INTERNATIONAL PLUMBING CODE

P2-07/08, Part II IRC R202

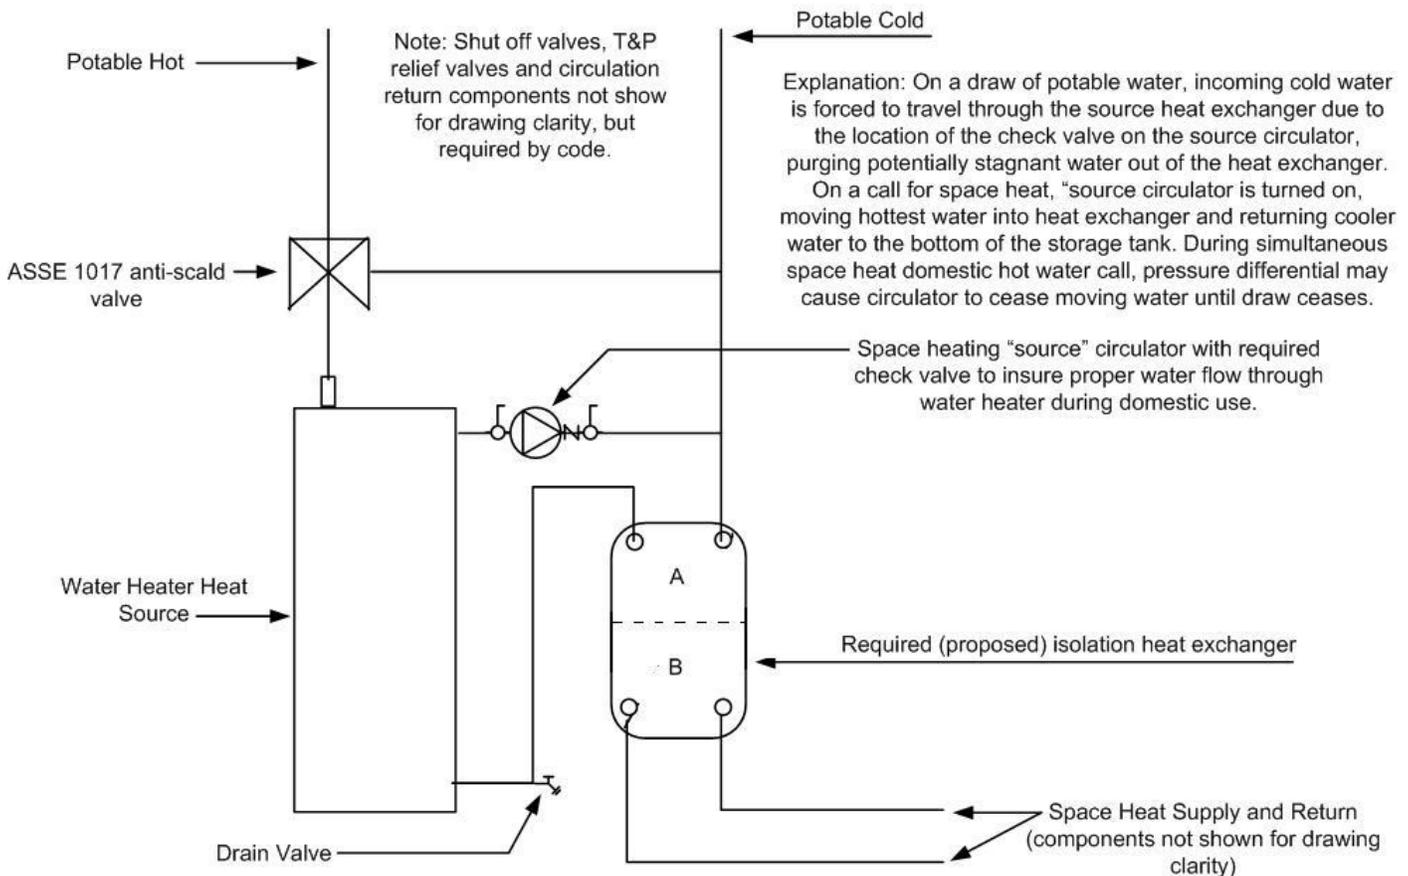
This stagnant, warm water is prime breeding ground for Legionella bacteria, the cause of Legionnaires' disease. Legionella bacteria are commonly found, in small numbers, in all potable water systems – both municipal and private well systems. Many studies have found that Legionella bacteria multiply when the following four conditions are met:

1. water pH of 5.0 to 8.5,
2. temperatures between 55F and 133F (with the ideal range being 80F to 122F),
3. stagnant conditions and
4. the presence of bio-films/rust/sediment (a food/shelter source).

The stagnant, warm water in the space-heating loop satisfies all the requirements for reproduction of Legionella bacteria.

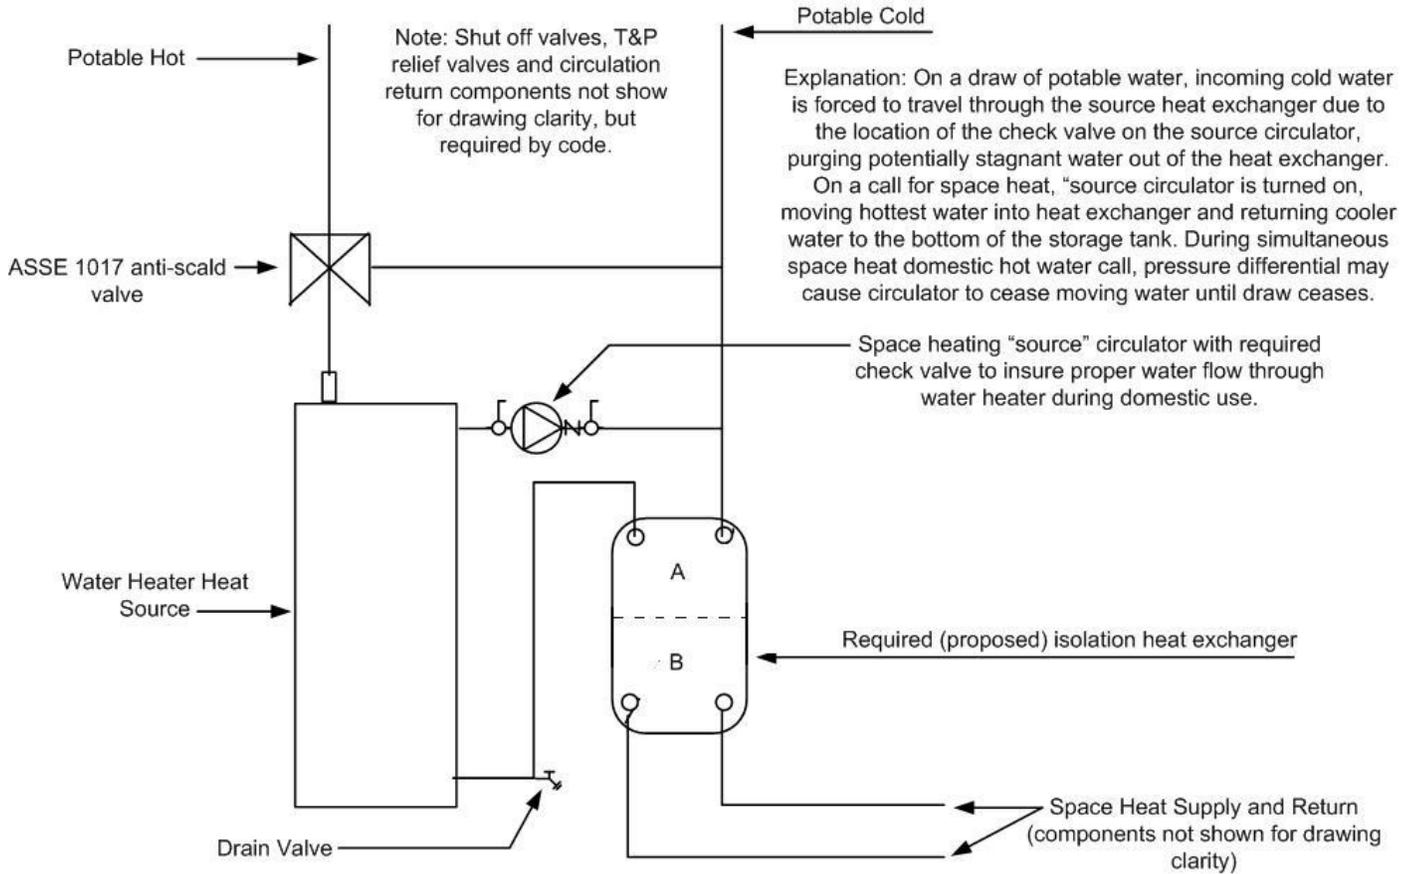
This stagnant, warm water is prime breeding ground for Legionella bacteria, the cause of Legionnaires' disease. Legionella bacteria are commonly found, in small numbers, in all potable water systems – both municipal and private well systems. Many studies have found that Legionella bacteria multiply when the following four conditions are met:

1. water pH of 5.0 to 8.5,
2. temperatures between 55F and 133F (with the ideal range being 80F to 122F),
3. stagnant conditions and
4. the presence of bio-films/rust/sediment (a food/shelter source).

The stagnant, warm water in the space-heating loop satisfies all the requirements for reproduction of Legionella bacteria.

Figure 12

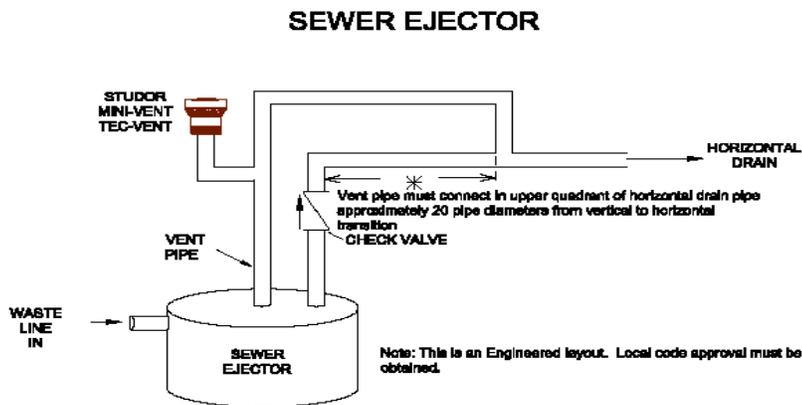
Commenter's Reason: There is no technical justification to require an engineer to design the installation of air admittance valves to vent sumps or tanks. Manufacturers Design Criteria and Installation Instructions provide a safe installation. See the following diagram:

Figure 12

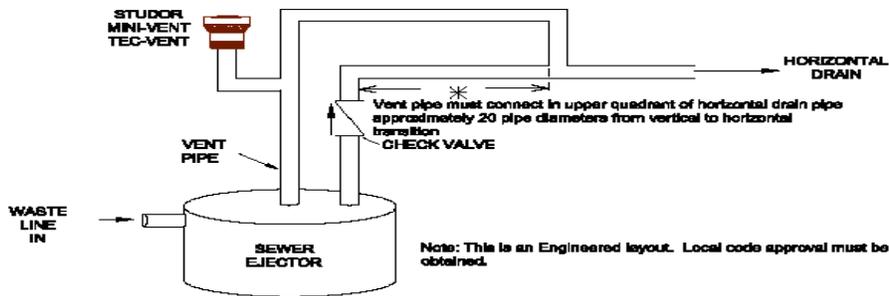
Commenter’s Reason: There is no technical justification to require an engineer to design the installation of air admittance valves to vent sumps or tanks. Manufacturers Design Criteria and Installation Instructions provide a safe installation. See the following diagram:
